**Response to EA Regulation 60 request for further information (11/02/14) – Narrative BATs**

**Summary snag list of knowledge gaps or issues captured from several meetings over Q2 -Q3 2013.**

**Tata Steel Scunthorpe BL3838IW PPC permit review to be transposed to a draft IED template permit during Q4 2013.**

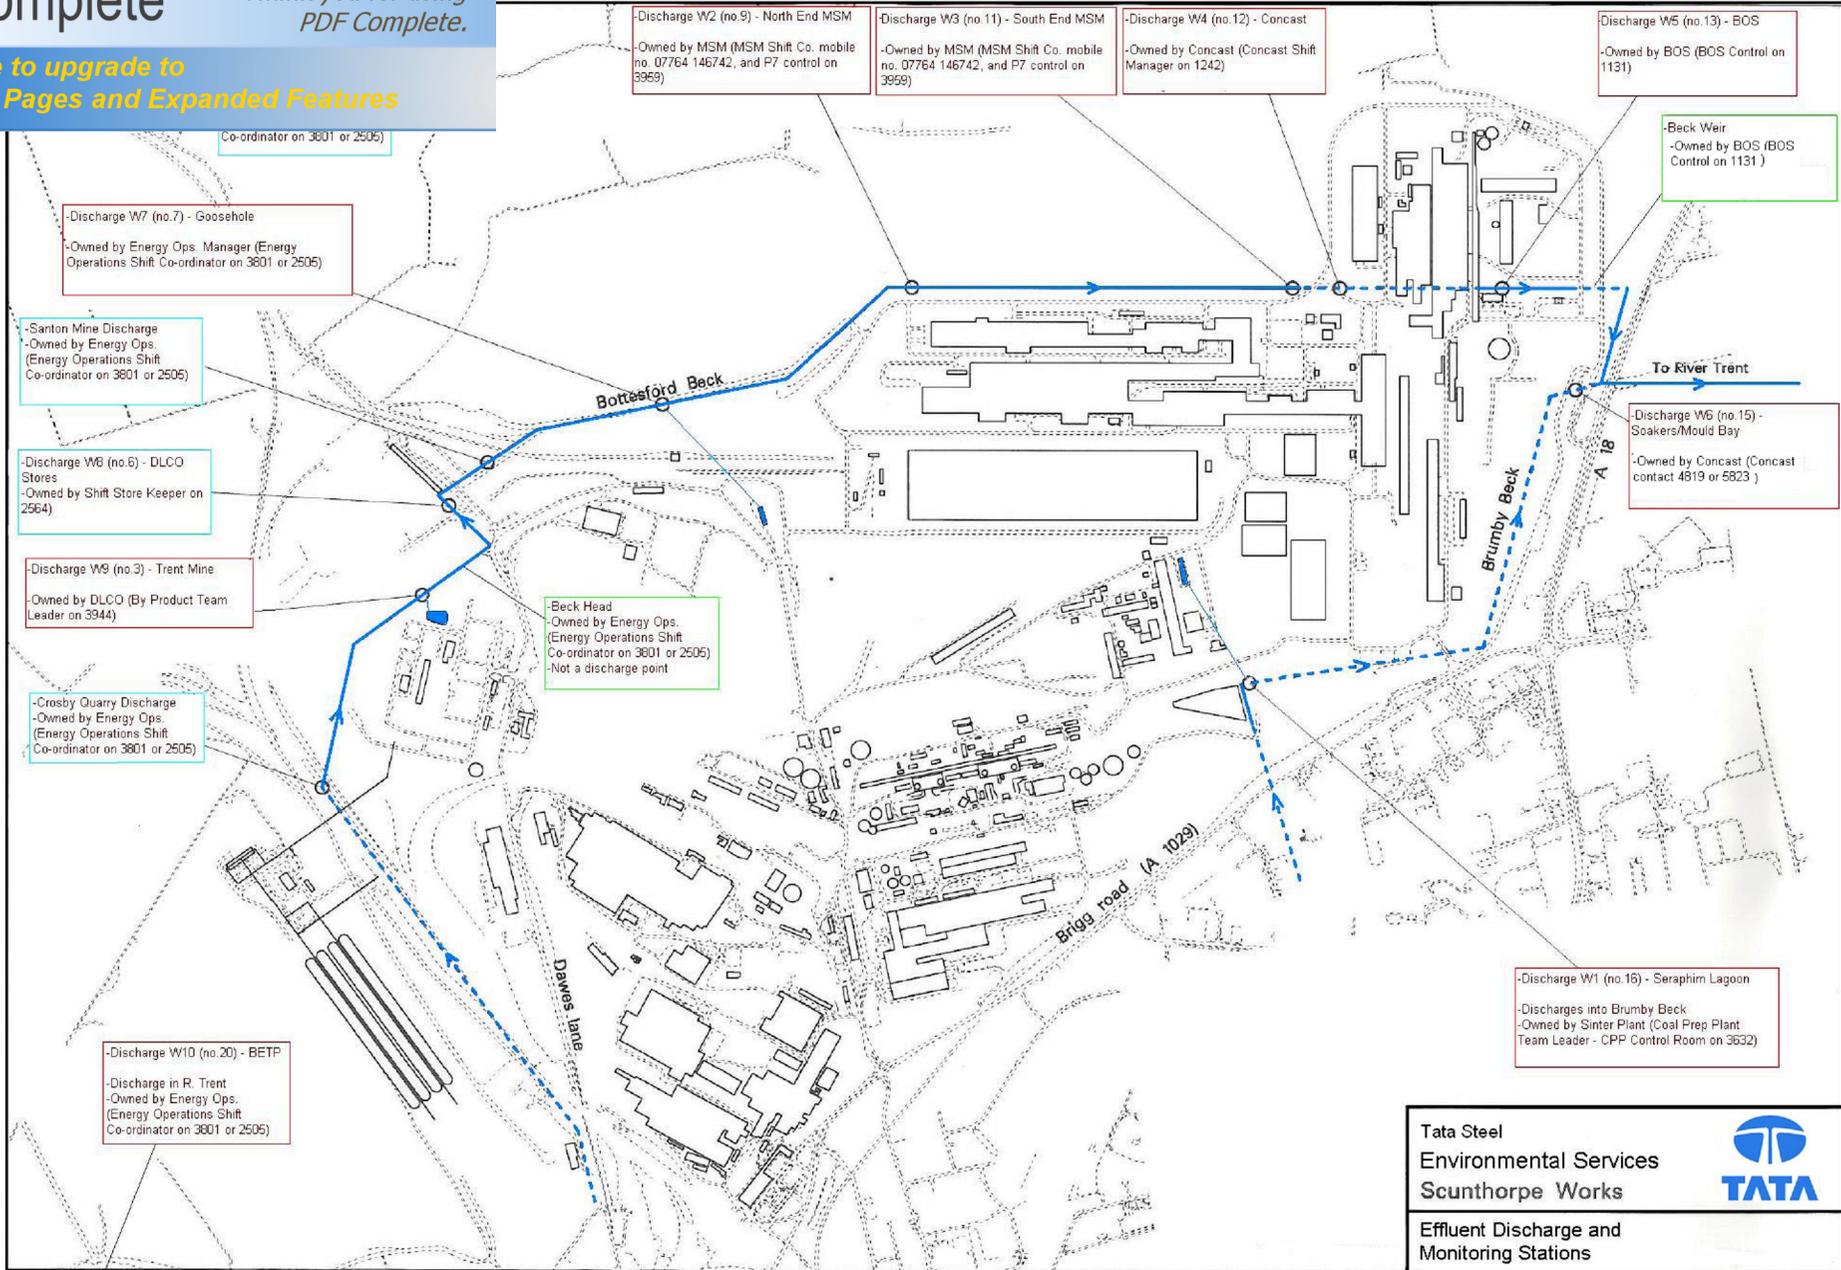
15	<p>Process emissions – air</p> <p>Process emissions - water</p>	<p>Address emissions from coal handling plant A3 &amp; A9.</p> <p>For waste water, specify the required procedure for sampling (e.g. random sample, qualified</p>	<p>Emissions from the sinter plant coal handling plant (sources A3 and A9) are not strictly covered in the BAT conclusions, however following discussions between the Environment Agency and Tata Steel it was decided that they shall be treated in the same way as coal grinding plants for coke ovens (BAT 42). As such, Tata Steel confirm that A3 and A9 will be subject to the BAT AEL of &lt;20 mg/Nm<sup>3</sup>. Each emission point</p>

BAT Conclusion (BATc) no.	Reference	Further information or justification required	Tata Steel response
		<p>random sample or composite sample) for each sample point to comply with their relevant BAT-AEL needs. Several pollutants with BAT-AEL limits are not currently sampled to BATc 15 requirements or monitored or have limited datasets, specify these and how you propose to gain datasets of statistical confidence to state if specific derogations are not required.</p>	<p>employs a policing continuous emissions monitor, however compliance is checked by annual spot samples.</p> <p>A number of questions relating to waste water have been answered in a separate document (<a href="#">Snag list response (water).doc</a>), which cover the list of pollutants with BAT-AELs which are not currently sampled as part of the existing permit.</p> <p>All samples will be qualified random samples in accordance with the requirements of the relevant BAT conclusions.</p>
